CONTRACT CHANGE ORDER NO. ____
SHEET ___ OF ___

SAN FRANCISCO OAKLAND BAY BRIDGE
EAST SPAN SEISMIC SAFETY PROJECT
SELF-ANCHORED SUSPENSION BRIDGE
(SUPERSTRUCTURE & TOWER)

TOWER ANCHORAGE DETAILS NO. 7

DOWEL ANCHORAGE CONTINGENCY DETAIL (see Note 2)
1:5

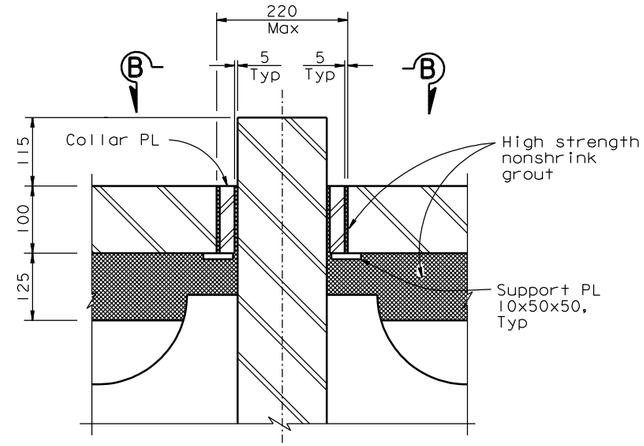
1. For dowel layout, see "Tower Anchorage Details No. 3" sheet.
2. Oversize hole in tower base PL is an acceptable alternative to accomodate tolerance requirements for the erection of the tower base plate. Collar plates shall be A709M Gr.345 and shall be fabricated based on field measurements and then installed.
3. The Contractor shall recommend an epoxy grout based on manufacturer's recommendations, subject to review and approval of the Engineer.
